RENESAS TECHNICAL UPDATE

Product Category	User Development Environment	Document No.	TN-EML-113A/EA	Rev.	1.0
Title	Correction of Errors in the H8S Family E10A Emulator Additional Document for User's Manual Specific Guide for the H8S/2218F E10A Emulator		Information Category	Correction or Supplement of Document	
Applicable Product	H8S/2218F E10A Emulator HS2218KCM01H HS2218KCI01H	Lot No.	Reference Document	H8S Family E10A Emulator Additional Document for User's Manual Specific Guide for the H8S/2218F E10A Emulator (REJ10B0018-0100H, Rev1.00)	
		V1.0.00

Please note that there are errors in the H8S Family E10A Emulator Additional Document for User's Manual Specific Guide for the H8S/2218F E10A Emulator (REJ10B0018-0100H, Rev1.00), which must be corrected as listed below.

Figure 1.2 Pin Assignments of the H-UDI Port Connector

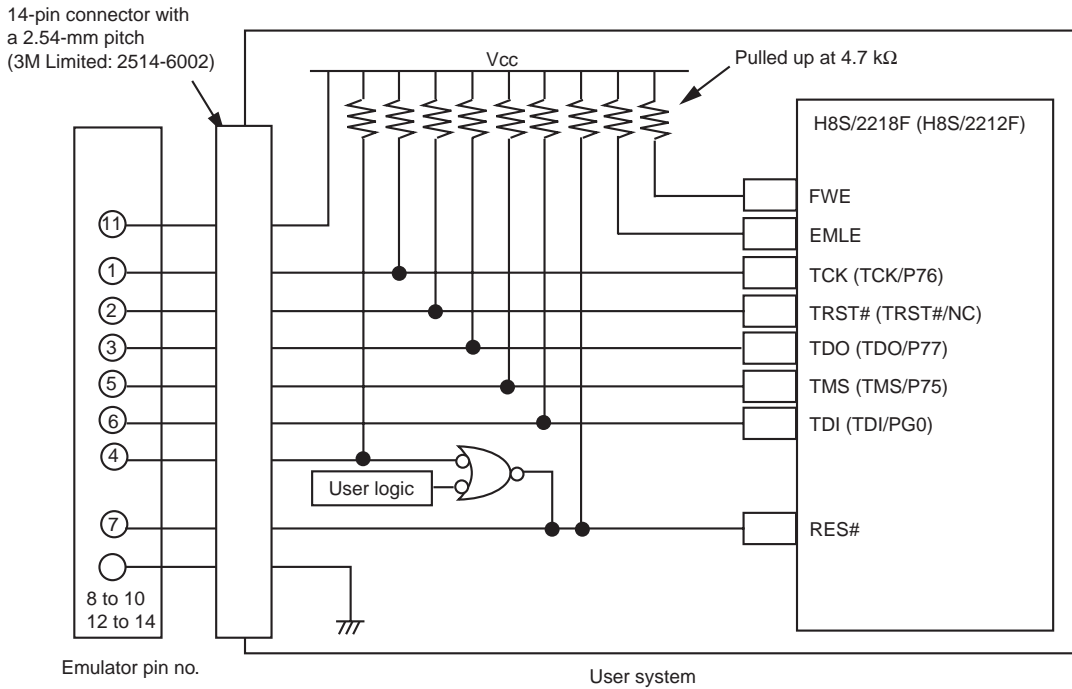
Correction 1: Figure 1.2 in page 3, figure 1.3 in page 4, and figure 1.7 in page 7

Pull up pin FWE. Due to a change of pin names for the H8S/2218F MCU, we have deleted the multiplexed names of the five pins.

Pin No.	MCU Pin Name H8S/2218F	MCU Pin Name *5 H8S/2212F	Input/Output *1
1	TCK	TCK/P76	Input
2	TRST#	TRST#/NC	Input
3	TDO	TDO/P77	Output
4	RES(in)# *2 *6	RES(in)# *2 *6	Input
5	TMS	TMS/P75	Input
6	TDI	TDI/PG0	Input
7	RES(out)# *2	RES(out)# *2	Output
8 to 10	GND *3	GND *3	—
12 to 14			
11	Vcc *4	Vcc *4	—

Figure 1.8 Connection of Pin FWE

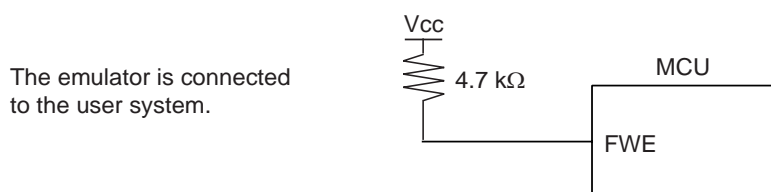
Correction 3: Note 7 in page 7

We have added description of the FWE pin processing.

7. Pin FWE must be pulled up if the emulator is connected to the user system.

Figure 1.9 TRST# of the H8S/2218F (Reference)

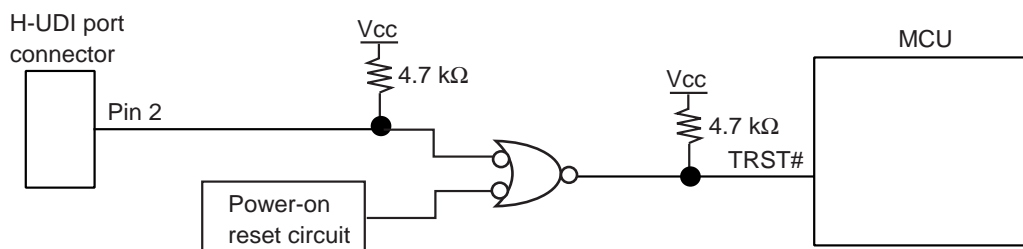
Correction 4: Note 8 in page 7

We have added description of a boundary scan function.

8. The H8S/2218F has a boundary scan function. To use the H8S/2218F without connecting the emulator, refer to the description in section 13.5, Usage Notes, in the H8S/2218F group hardware manual, and connect the H8S/2218F to the emulator.
